**APPENDIX A**  
**PERTINENT CORRESPONDENCE**

RE: Department of the Army – Jacksonville District Corps of Engineers – Final  
Environmental Impact Statement (FEIS) – Proposed Modifications to Project Features  
North of the Fellsmere Grade (CC#5H) Central and Southern Florida Flood Control  
Project – Upper St. Johns River Basin and Related Areas – Brevard County, Florida  
SAI: FL200307083007C

RE: U.S. ACOE - Jacksonville District - Draft Supplementary EIS - November 2002 - Modifications to Project Features North of the Fellsmere Grade Central and Southern Florida Flood Control Project - Upper St. Johns River Basin and Related Areas - Brevard County, Florida.  
SA# 200211123077C

1. Location and project features of the TFMCA and the SJMCA.

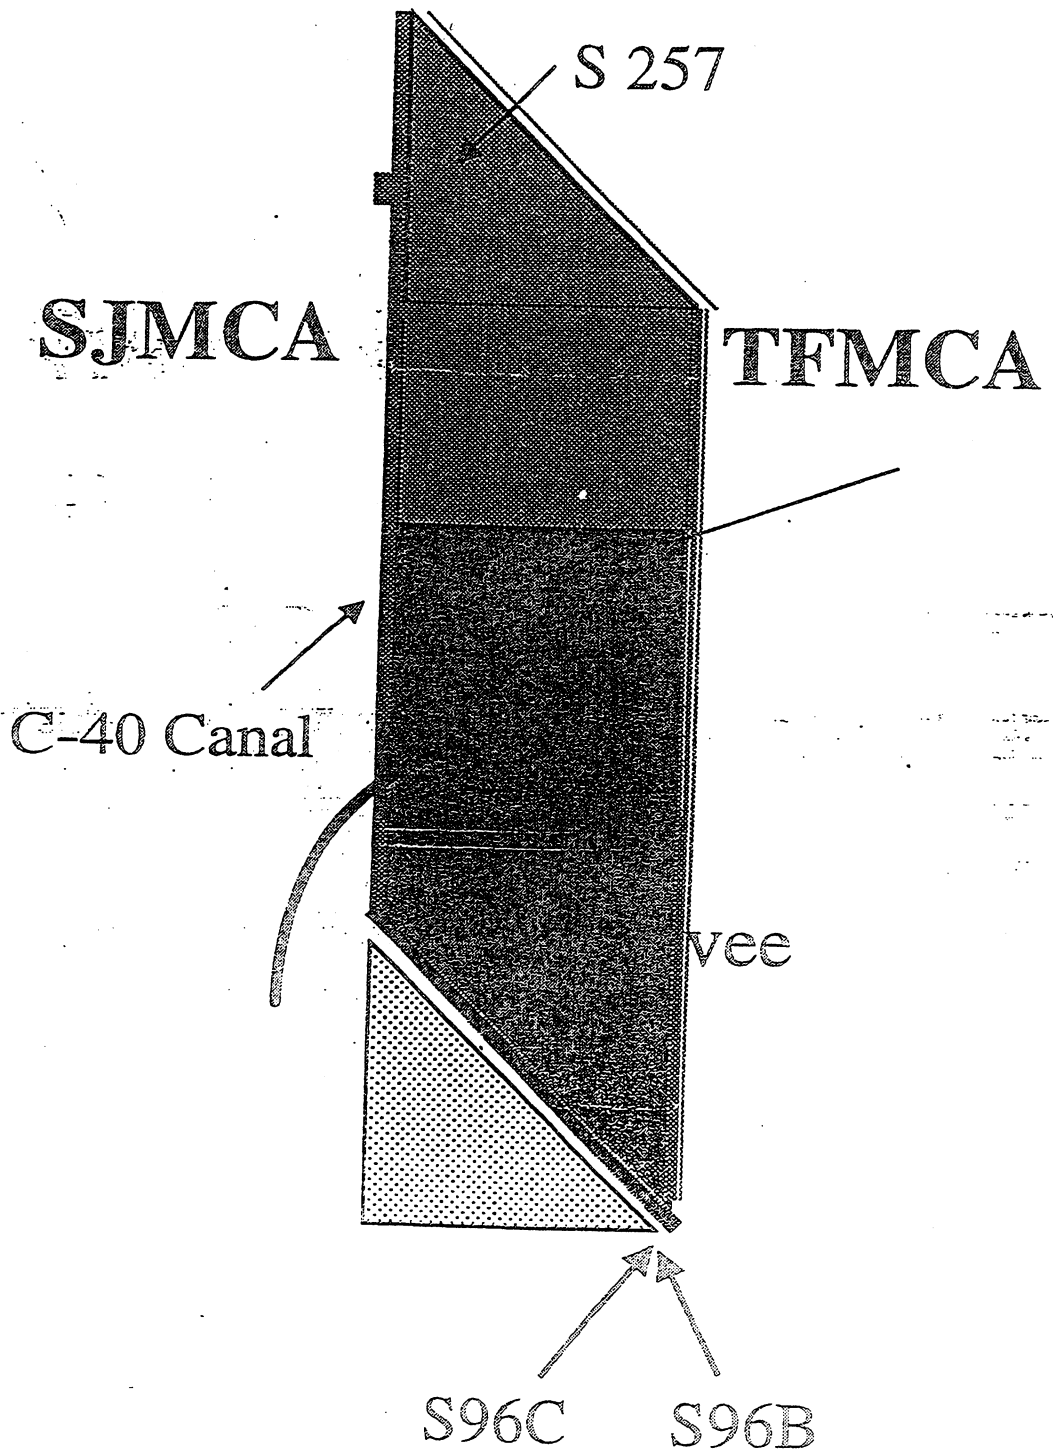
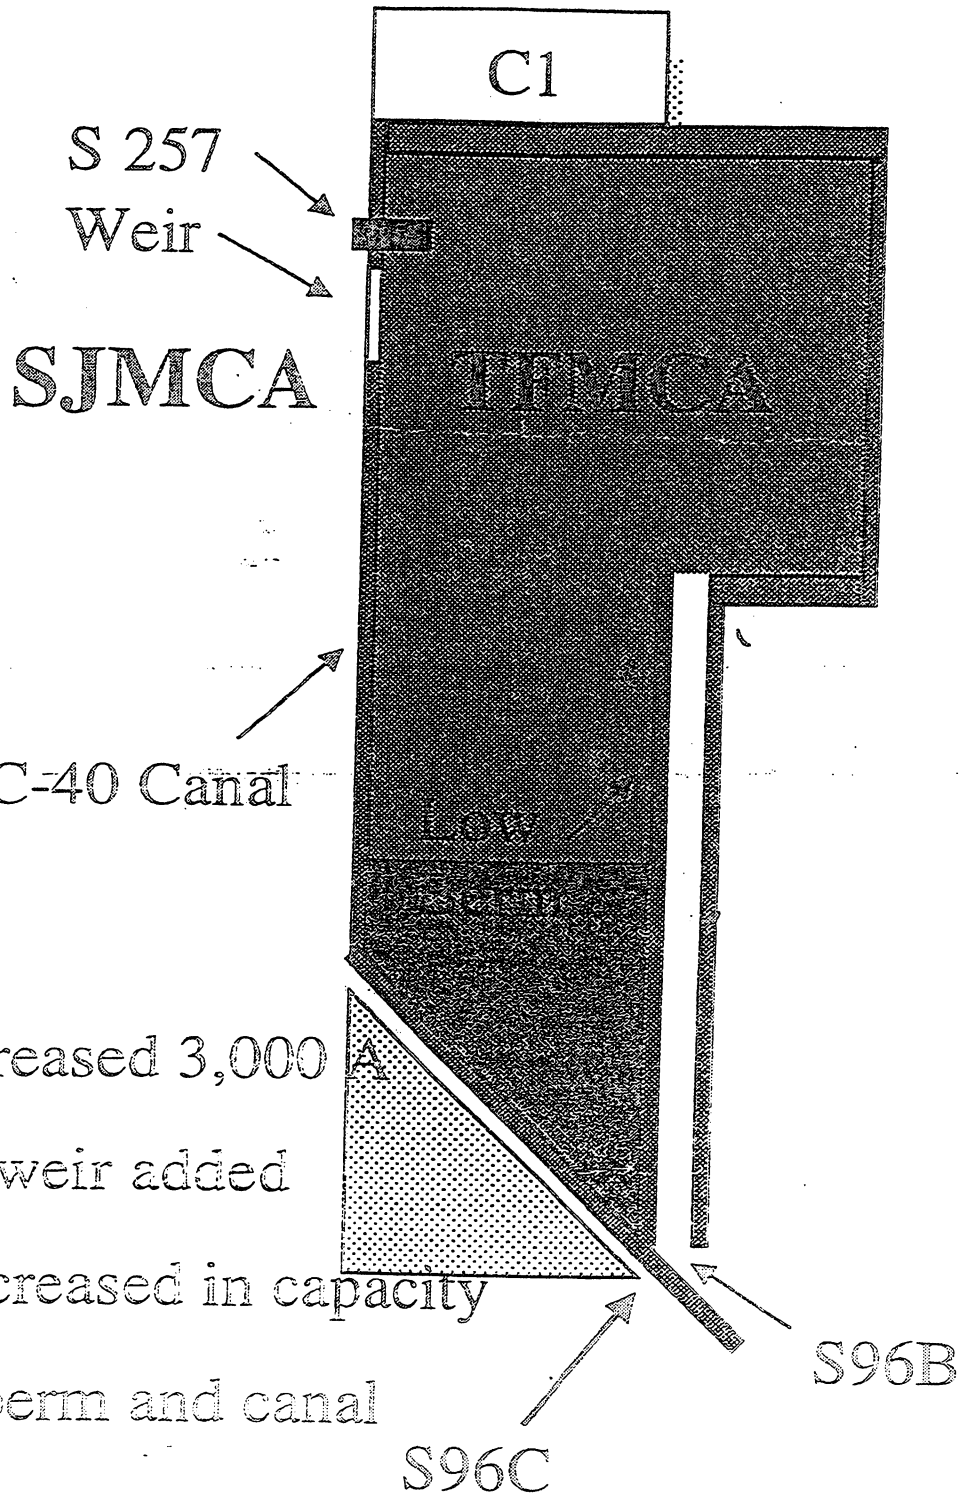
- 1) Area Increased 3,000 A
- 2) Outflow weir added
- 3) S-257 Increased in capacity
- 4) Internal berm and canal

Figure 1. Map showing features of a proposed modification of the 50/50 split plan (Crosshatching denotes areas to be hydrologically reconnected with the St. Johns Marsh Conservation Area).

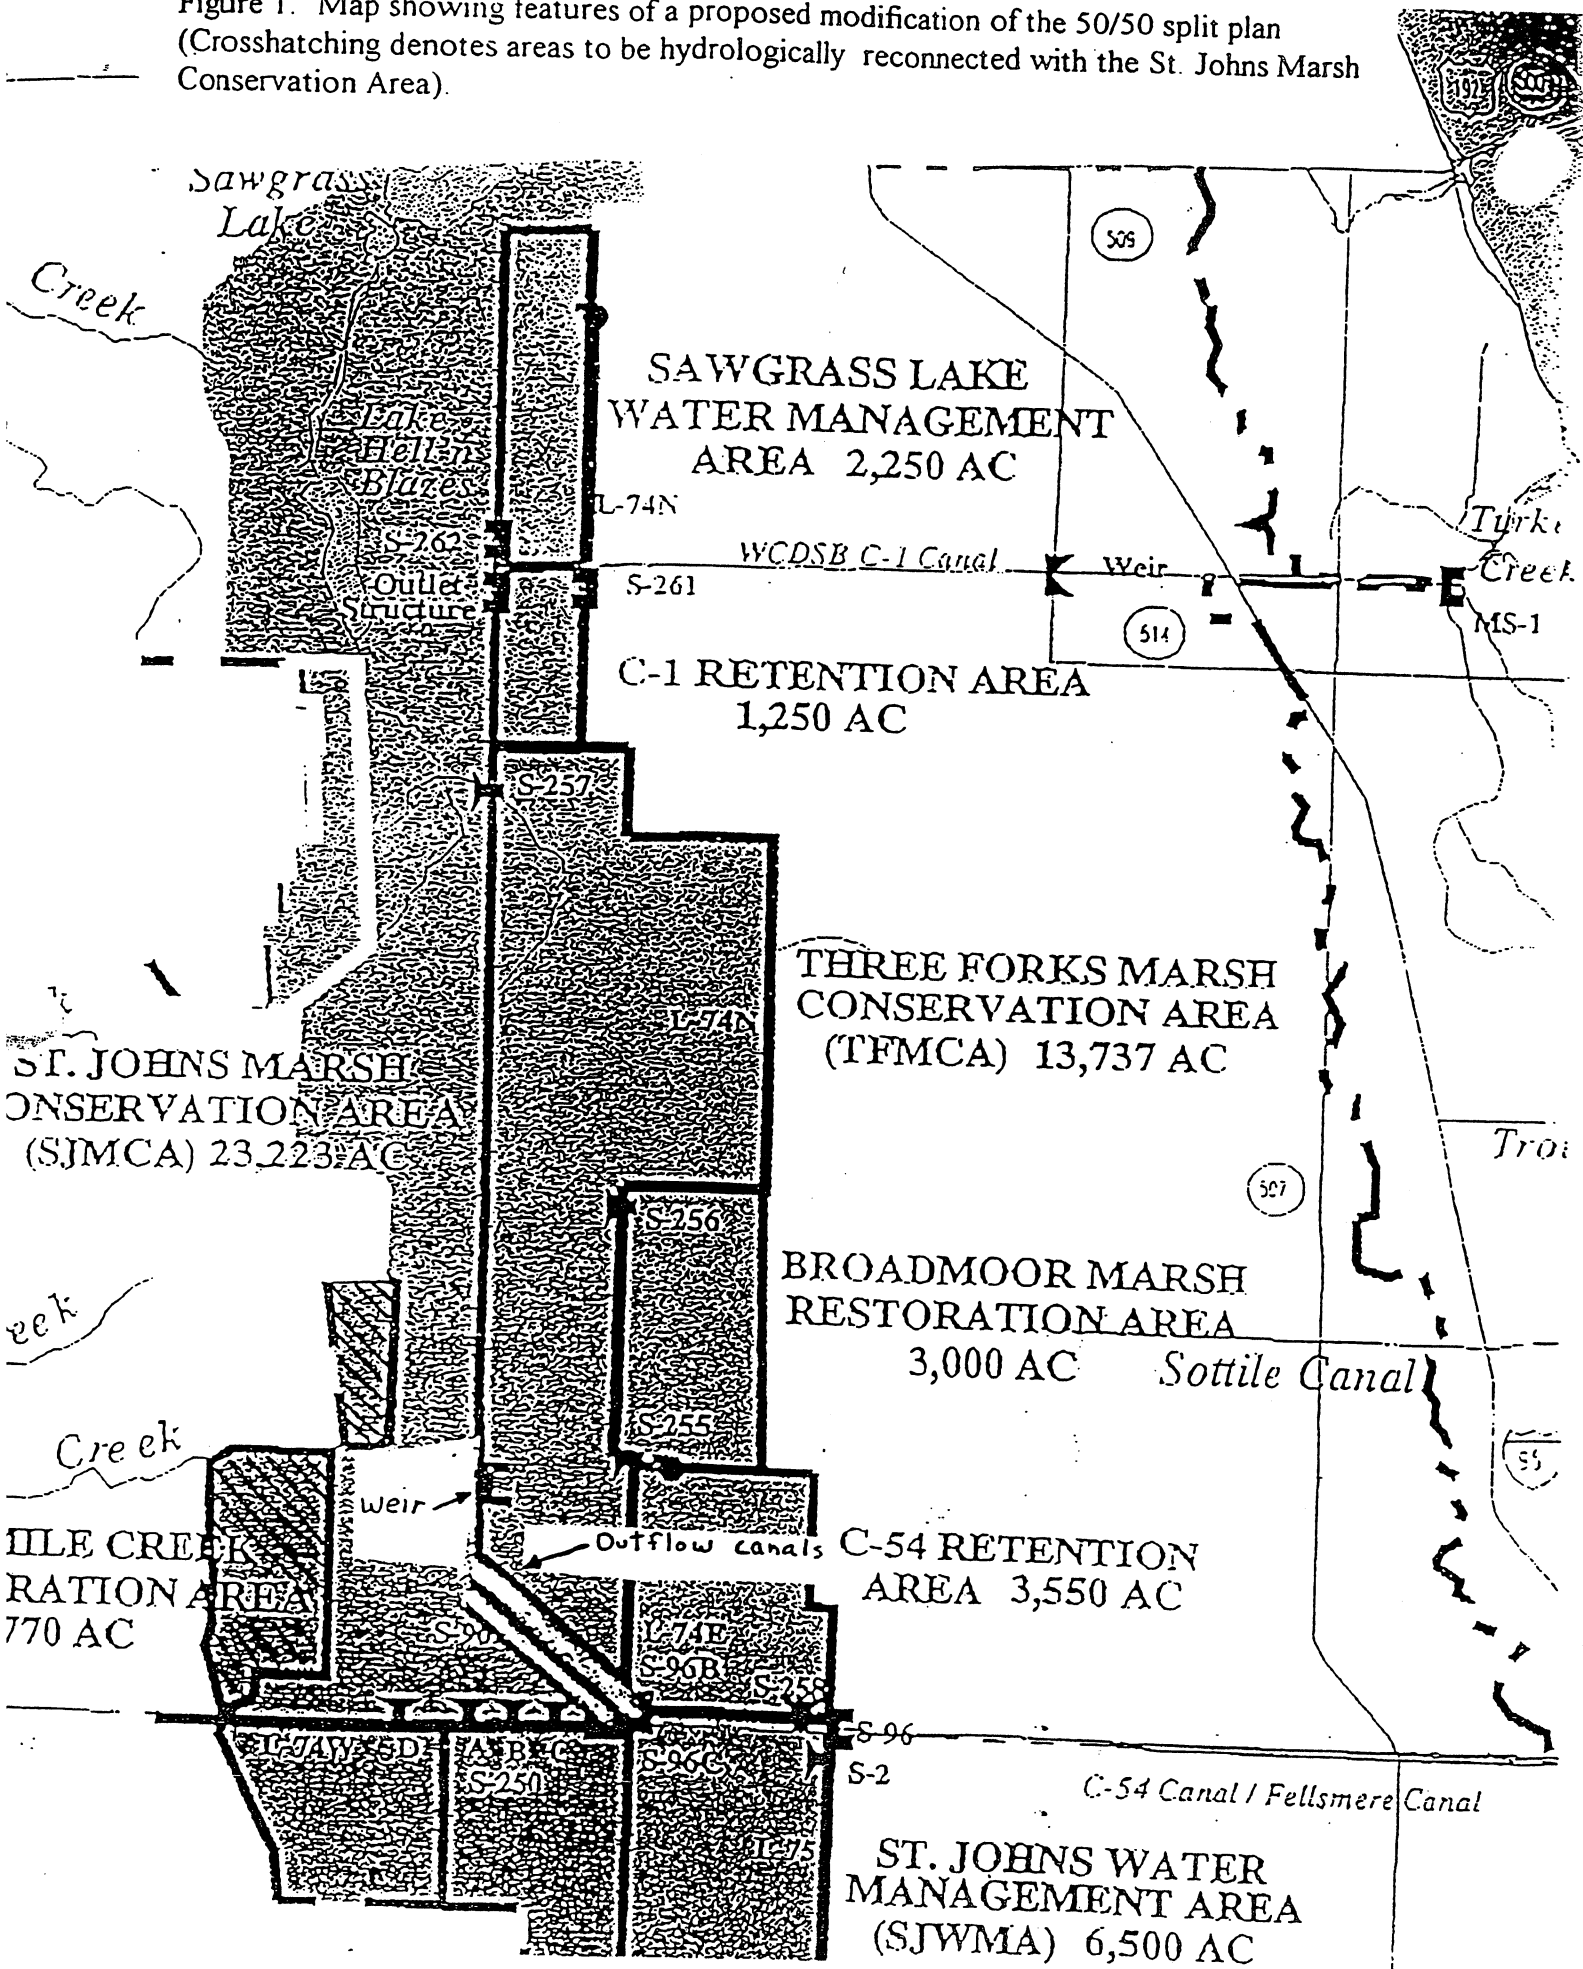
We believe that the discharge of nutrient-rich water to the marshes of TFMCA and SJMCA should occur as far upstream as possible. Such an approach would allow natural marsh systems to work in conjunction with established Water Management Areas in the treatment of poor quality water. One possible scenario would be a modified version of the 50/50 split plan (see Fig. 1). The S-96B get-away canal could be excavated parallel to the S-96C get-away, with the existing dike separating the two canals. Both canals would empty into the SJMCA. The S-96E spillway could be located well downstream of these canal outfalls, but still allow water to flow from the SJMCA into the southern portion of TFMCA.
